Public Meeting Safety Classification of Structures Systems and Components

August 5, 2020

FSAR Figure 4 -1 : Relationship of PDC to the Design Basis

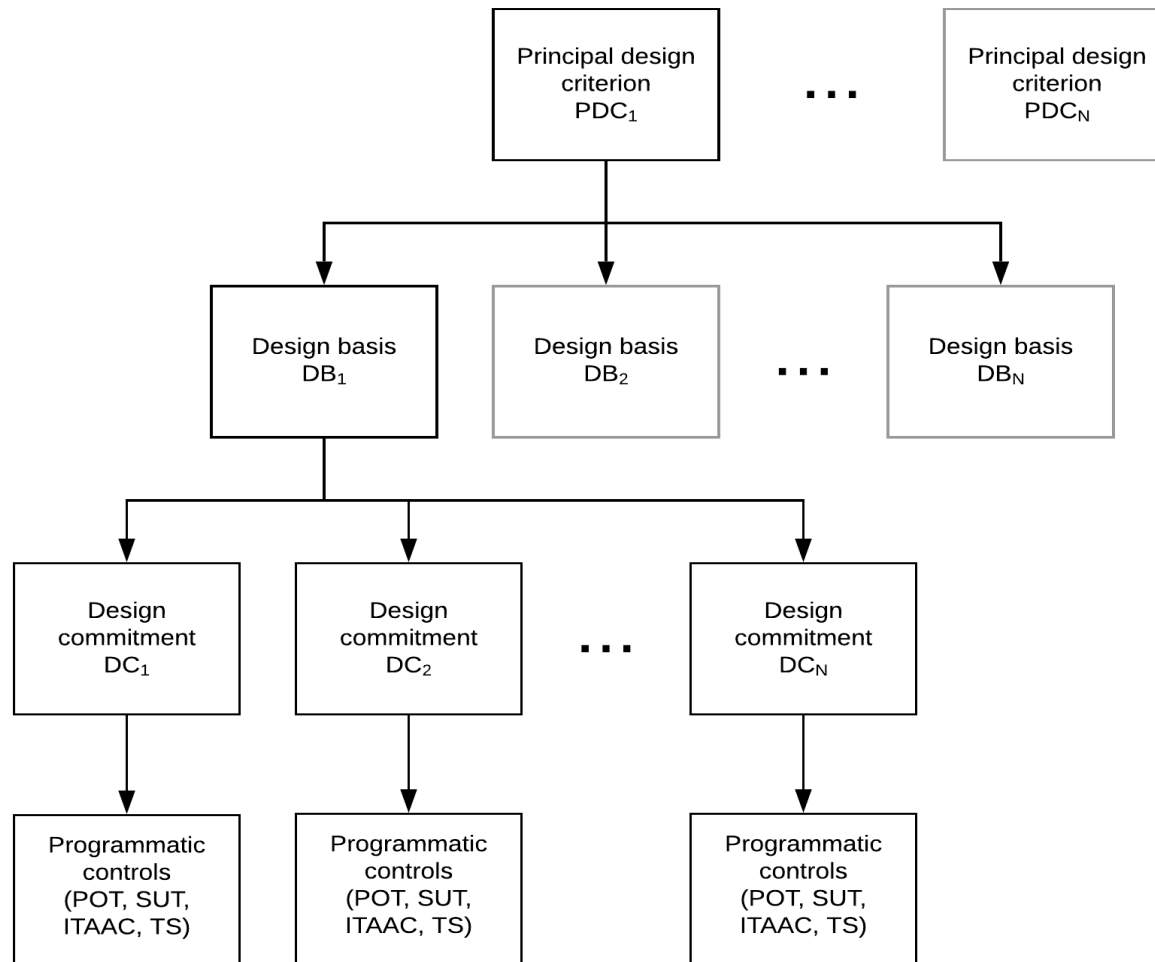
- The staff needs to understand the methodologies and outcomes related to the maximum credible accident (MCA), other potential events, mechanistic source term (MST), and related topics so that it may further assess the proposed approach for establishing design basis, design commitments, and testing for specific SSCs
- Using an approach similar to RG 1.233 to identify RSFs would likely require an assessment (but not necessarily incorporation into licensing basis events) of the potential offsite dose that could result from unprotected plant transients
- Approaches similar to RG 1.233 also place additional importance on the identification of performance criteria and related special treatment for SSCs that are determined to contribute to the safety case in terms of risk assessments or providing defense in depth.
